Burlington Design Advisory Board

DESIGN ADVISORY BOARD Tuesday 28, 2020 3:00 PM REMOTE MEETING

MEMORANDUM

To: The Design Advisory Board
From: Mary O'Neil, AICP, Principal Planner
RE: ZP20-0875CA; 115- 117 North Union Street
Date: July 28, 2020

Revisions to 115 N Union Project Proposal

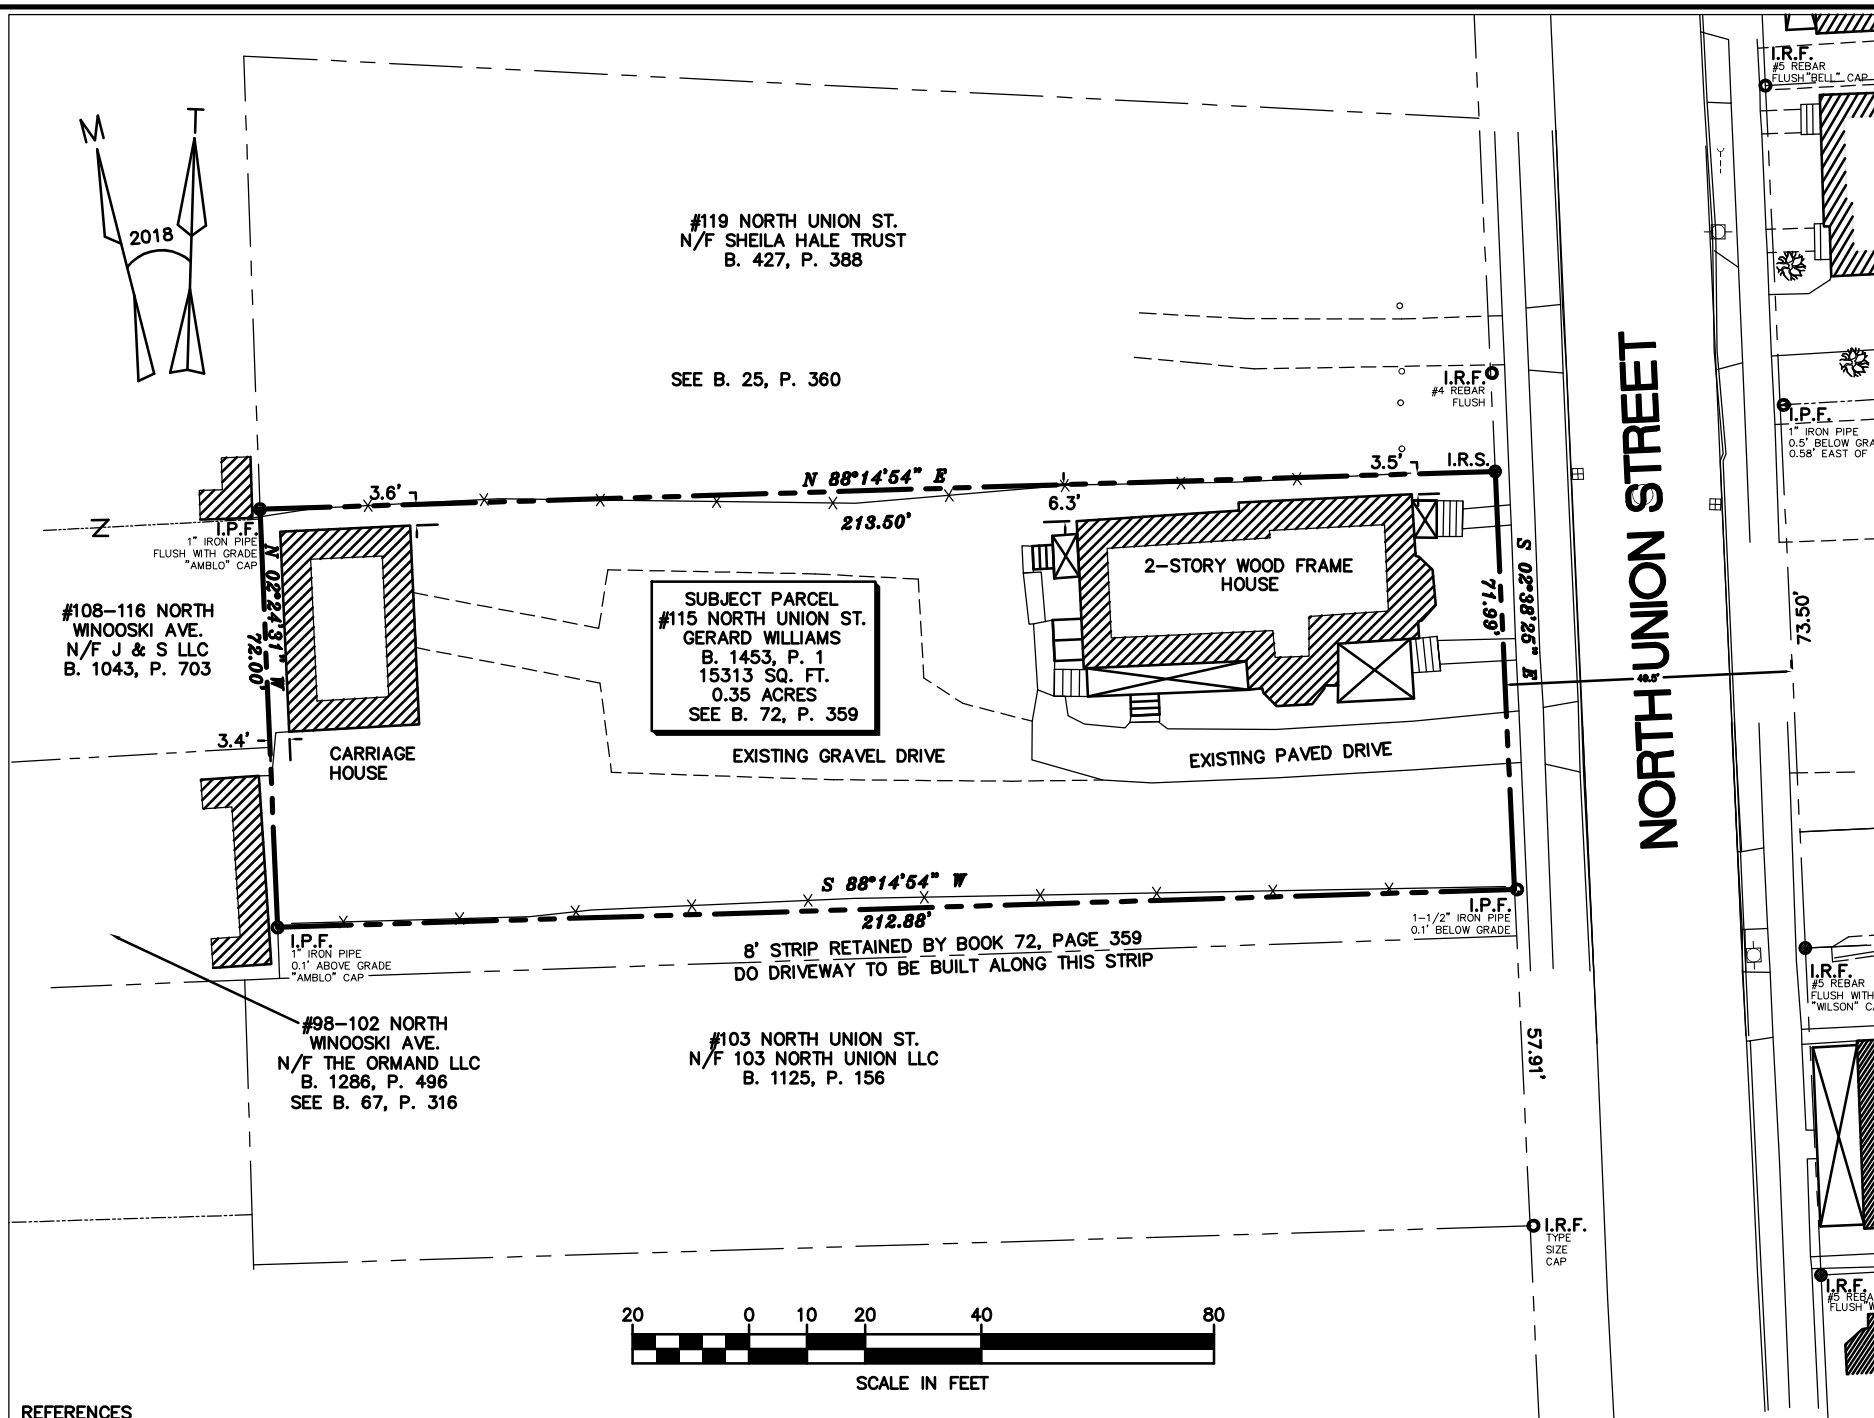
ITEMIZED changes (Friendly amendments)

- Updated site plan:
Property has been surveyed and new pins set. New site plan is drawn using survey data for locations of all structures.
Updates include moving cottage west on lot to allow more room for parking on its east side.
Locations of utilities, meters and mailboxes.

- Updated parking quantities and layout:
Back up areas increased to 16' with a curb on all spaces to allow bumper to extend further over lawn.
A permeable concrete grid is in front of entire carriage house now to provide for back up and turn around of indoor parking spaces.
Options for 10 spaces or 8 spaces if DRB accepts parking plan.
A 6 space plan, if accepted, could also greatly improve parking flow and usability of doors on carriage house.

- Comments supportive of changes in the gable
Victorian gable ornamentation options for review
- Showing the details or how the cladding relates to the main house (tie in to detail in the trim) or provide historical
Added horizontal gable trim boards and skirt board at grade to mimic carriage house.
Also found a blurry historical photo showing a possibly shingled structure in that location.
Added Crown molding to Cottage roof trim and bed molding to frieze to match carriage house.

115 N Union Parking Plan:

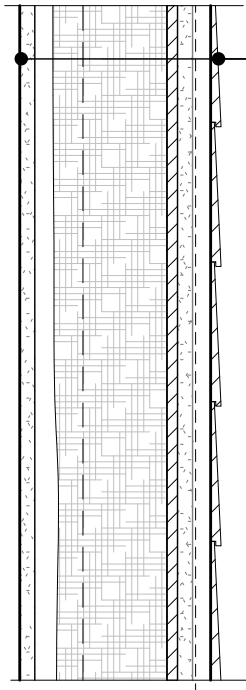
We would like to petition the DRB to consider allowing one parking space for each single bedroom unit on the property instead of two in order to increase green space and improve flow. Expansion to the property involves converting carriage house into a single bedroom apartment and building a new 1 bedroom cottage in the mid section of the lot. Two of the three existing apartments in the main building are also single bedroom. A full 10 space plan is possible and has been designed by utilizing two indoor spaces inside the carriage house. Garage doors will be used for access and wooden barn doors added to maintain historical accuracy. This is a better design for occasional use and storage rather than daily parking. A back up area for carriage house spaces also adds a large area that needs to be drivable through use of a permeable concrete grid. The 10 space plan also requires 6 spaces to be placed next to the main house which creates an awkward turning and backup scenario. Both DAB and owner agree that it is not ideal and may not be necessary given the occupancy of the property. We propose to use the first room in the basement to provide a heated and locked bike storage area that will accommodate up to 8 bicycles for daily use and accessible to all. Six parking spaces would be provided. One for the carriage house apartment and one for the cottage apartment in the back of the lot. Four spaces would be supplied closer to the main house, two for the upstairs apartment and one each for the two downstairs apartments.

If the six space plan is not acceptable, we will make use of the parking spaces inside the barn and install the large backup area for a total of 8 spaces.

- The site plan showing 8 parking spaces and a footpath leading to the carriage house is approved. We recommend approval of a 2-space parking waiver, for a total of 8 parking spaces on the site to serve the 5 residential units, given the location of the building in the city and the smaller size of each residential unit, mostly 1-bedroom.
